GENOA CHARTER TOWNSHIP PLANNING COMMISSION PUBLIC HEARING MARCH 9, 2020 6:30 P.M. AGENDA

Attention:	Kelly Van Marter, AICP
	Planning Director and Assistant Township Manager
Subject:	Work Skills Corporation – Special Land Use and Sketch Plan Review #1
Location:	3201 East Coon Lake road – north side of East Coon Lake, between Chilson and Westphal
	Roads
Zoning:	CE Country Estate District

Attention:	Kelly Van Marter, AICP
	Planning Director and Assistant Township Manager
Subject:	Integrative Veterinary Services – Special Land Use and Sketch Plan Review #1
Location:	2829 East Grand River Avenue – north side of Grand River, east of Chilson Road
Zoning:	GCD General Commercial District

Dog elimination area. West of building, off of the parking lot.

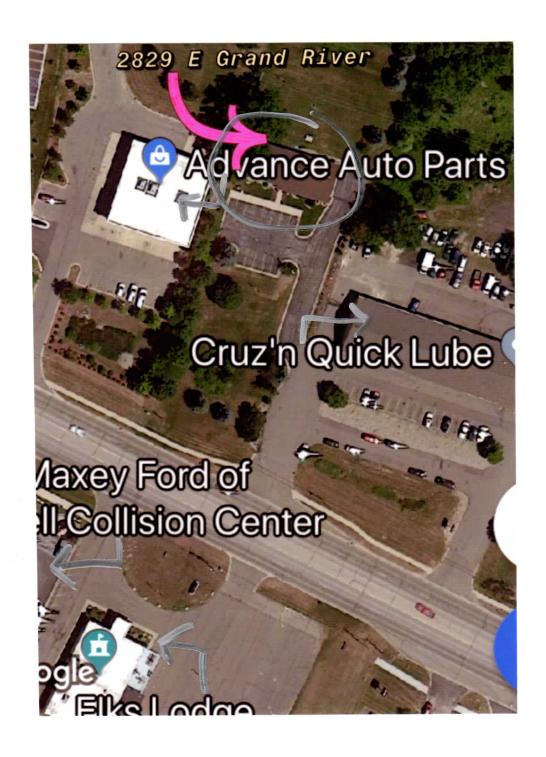
The submittal includes the approved site plan from 1998. While this plan does not identify the outdoor animal area, the supplemental material included with the submittal provides photographs, notes and a written description for the required area on the west side of the building.

This area is comprised of an existing lawn and the applicant will provide signage, a bag dispenser and a container for any waste. The submittal notes that this area will be inspected daily with any waste cleaned up and disposed of by staff.

CS101

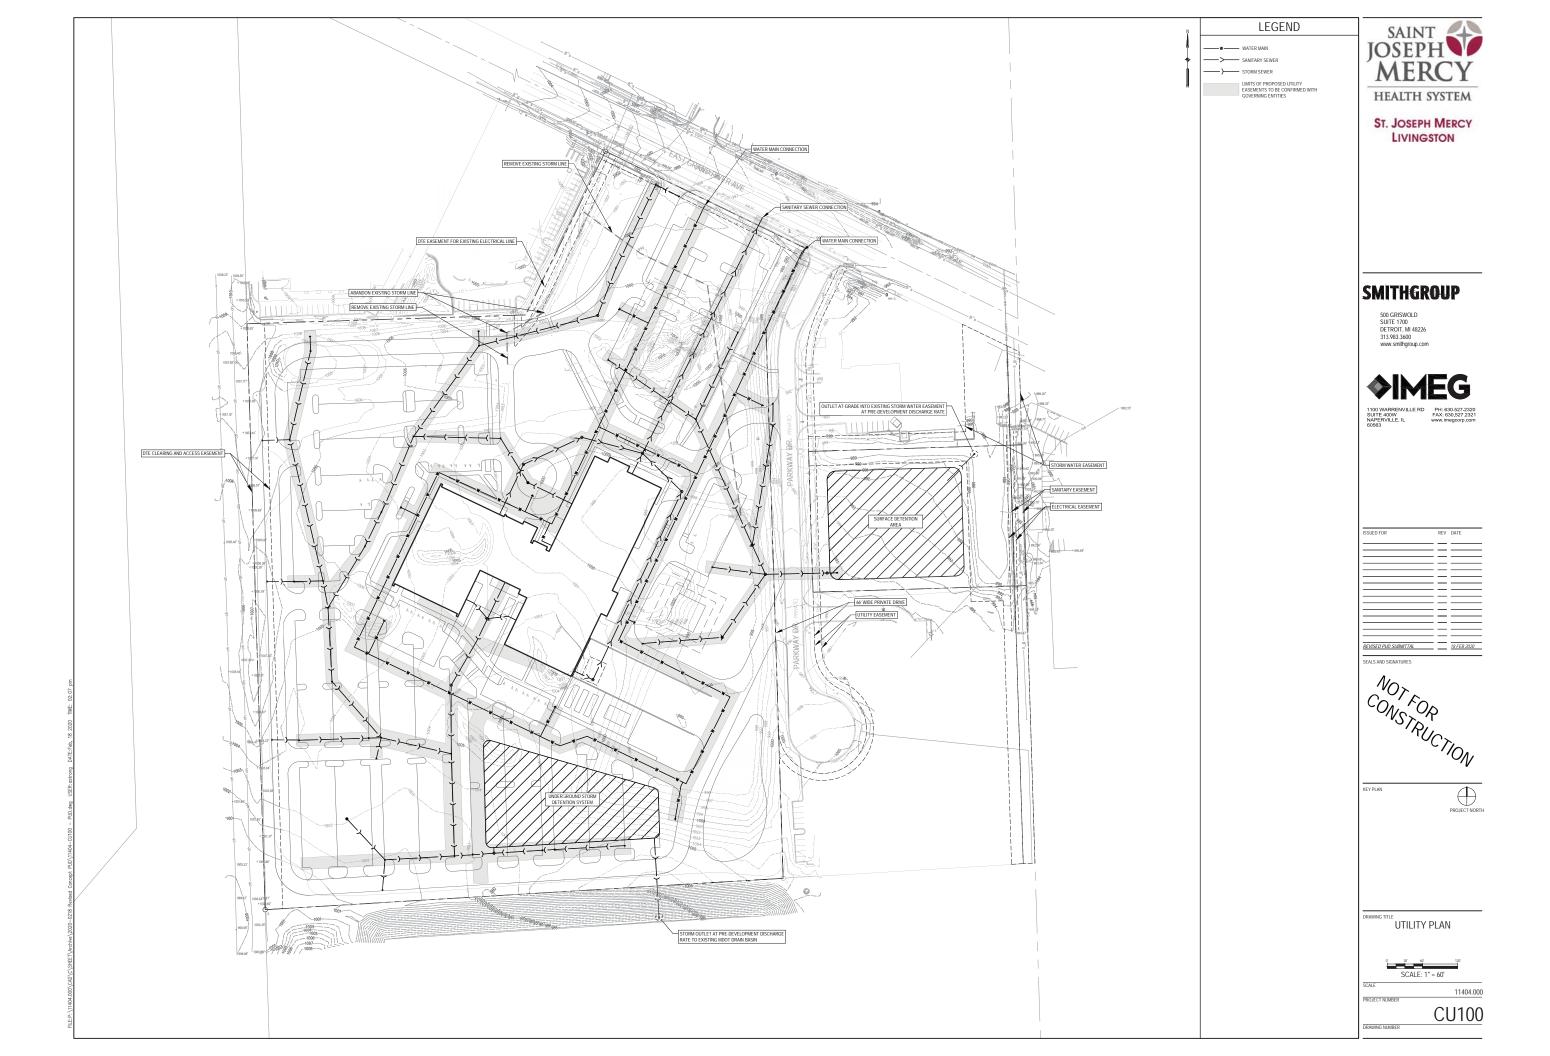
The concept plan includes one main driveway along Grand River and proposes two connections to Parkway Drive; however, a revised Sheet CS101 eliminates the connections to Parkway Drive.

SCALE	11404.00
PROJECT NUMBER	
	A-100
DRAWING NUMBER

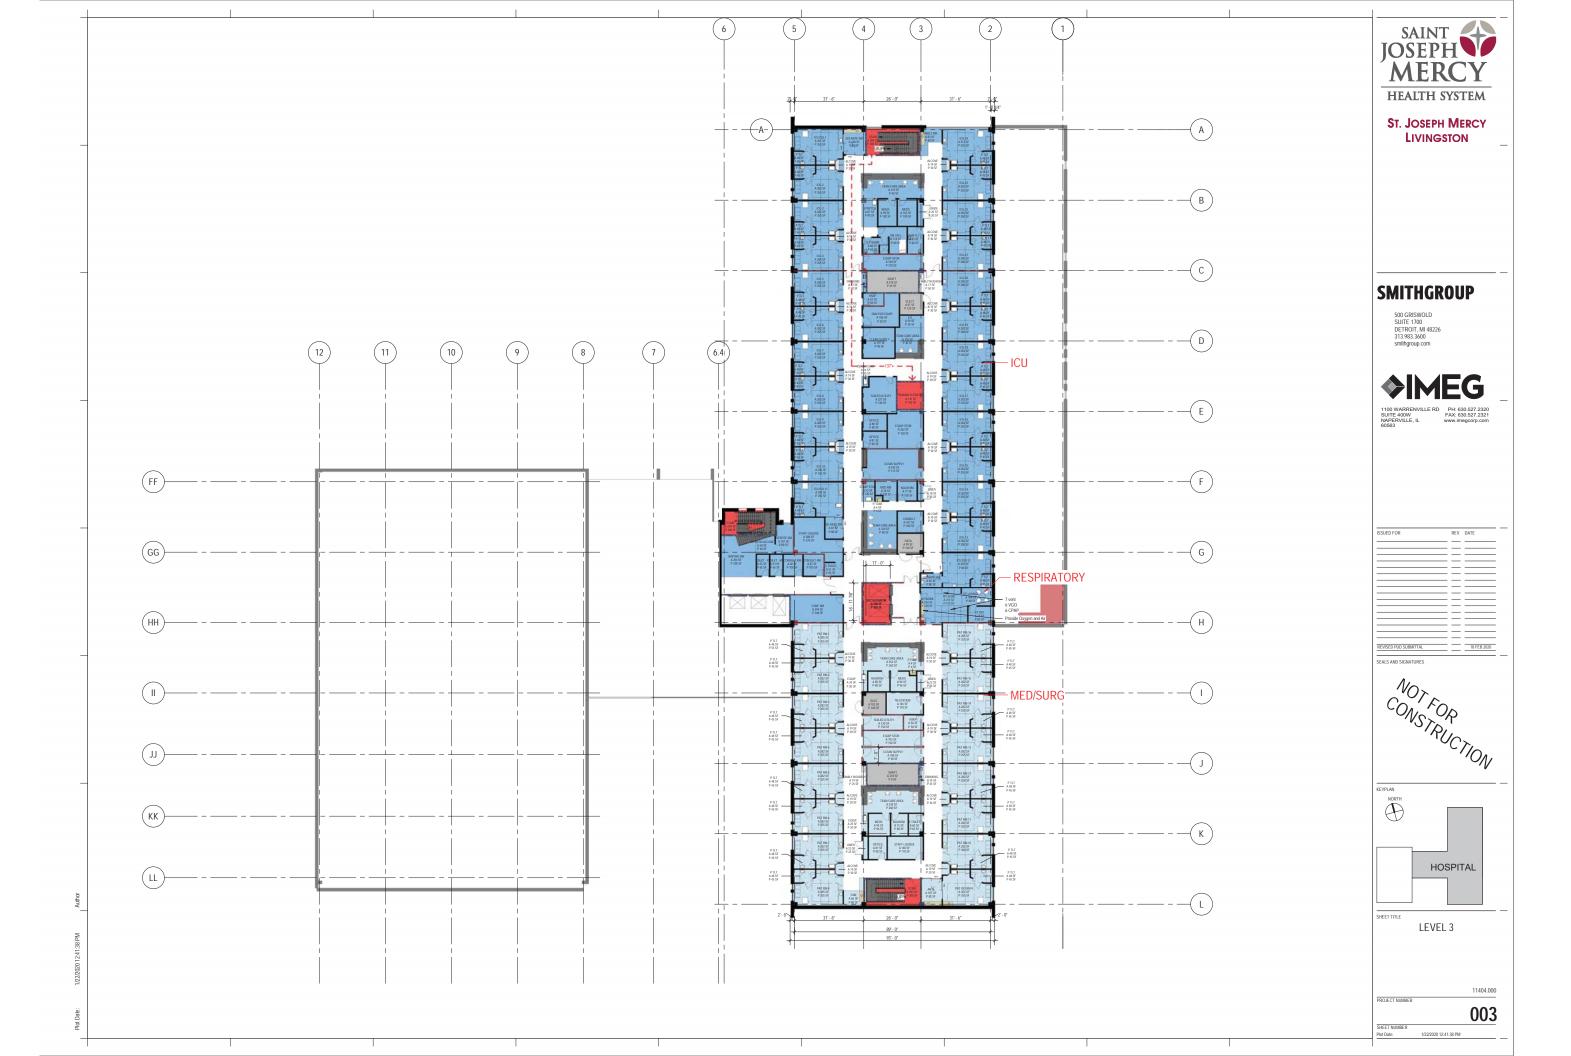
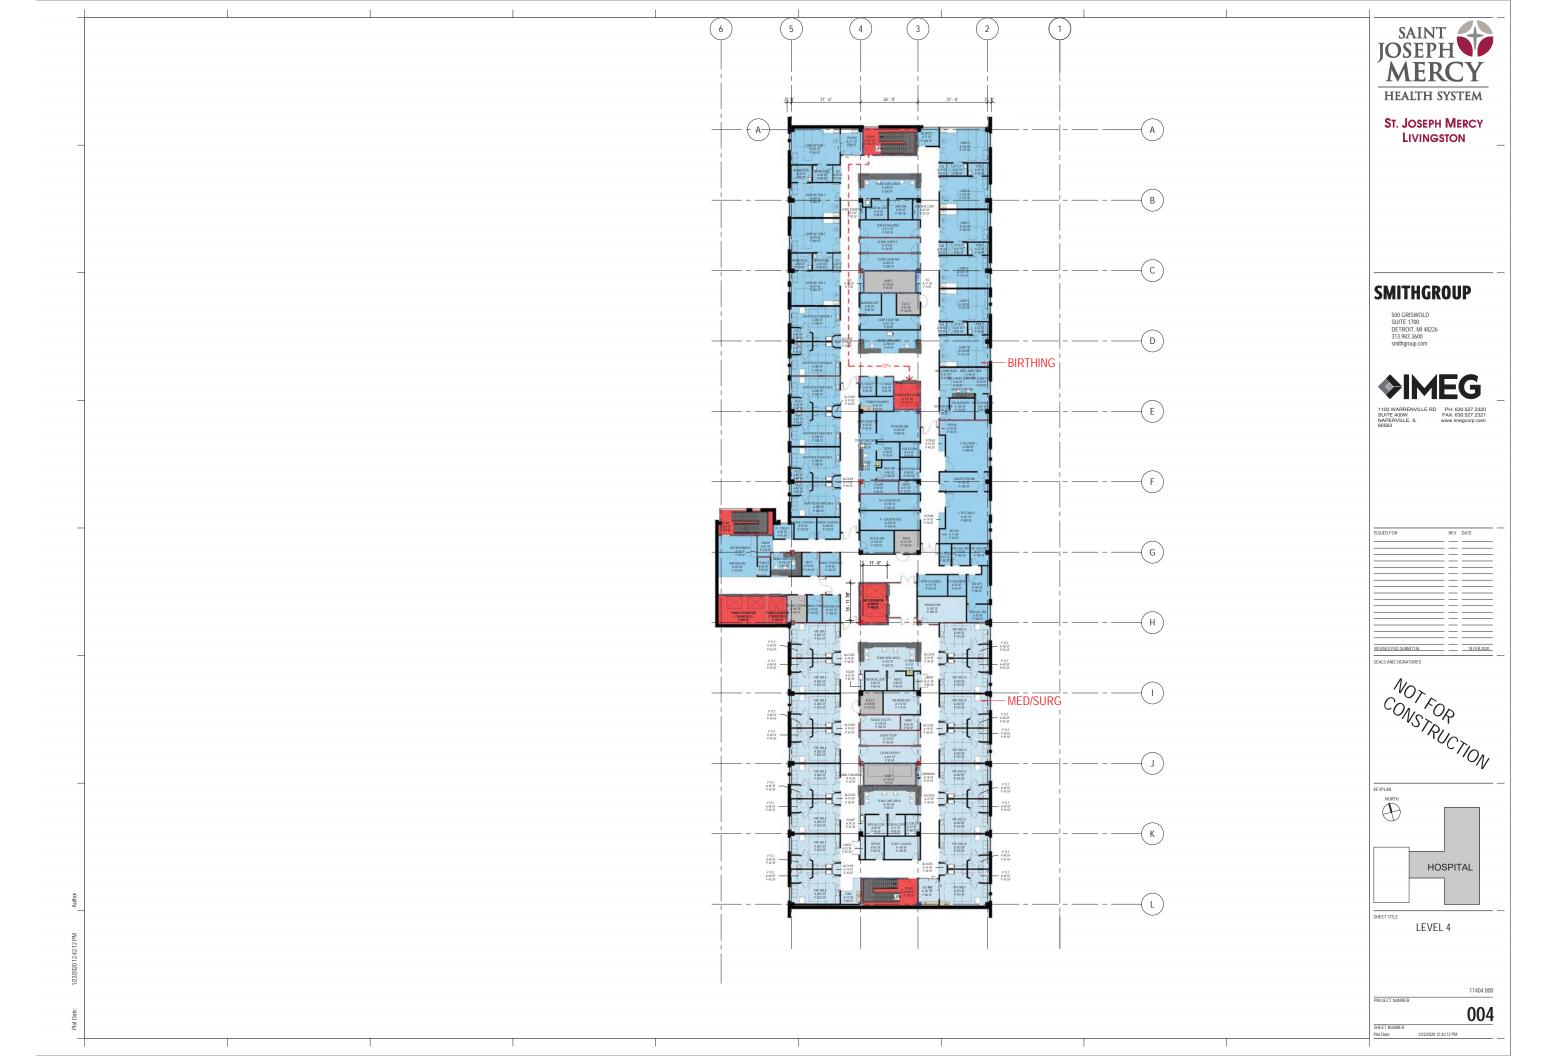
6. Architecture. The submittal includes a color rendering/perspective of each building façade (Sheet A-100). This drawing includes the proposed building materials and calculations for each façade.
